REFERENCE: RECON 25/0152

PROPOSAL: RESERVED MATTERS APPLICATION RELATING TO LAYOUT, SCALE, APPEARANCE, ACCESS AND LANDSCAPING FOR RESIDENTIAL DEVELOPMENT AT PHASE4E/4G

SITE: Glan Llyn Development Site Phase 4E/4G

RECOMMENDATION: NO OBJECTION – but note concerns

Lack of tree planting – planting plan 2 of 7 including opposite the bridging point across central lake is a focal point	 Lack of tree planting – planting plan 3 of 7
 Lack of tree planting – planting plan 4 of 7	 Lack of tree planting – planting plan 6 of 7

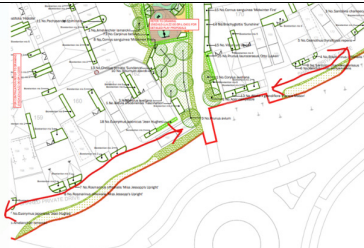
1. Lack of tree planting within SuDS swales

As per my previous comments, the road corridors highlighted below have no tree planting within the SuDS swales which will result in poor views dominated by a two-dimensional landscape of grass and hard surfaces. Swales are not a constraint to tree planting and proposals should be revised.
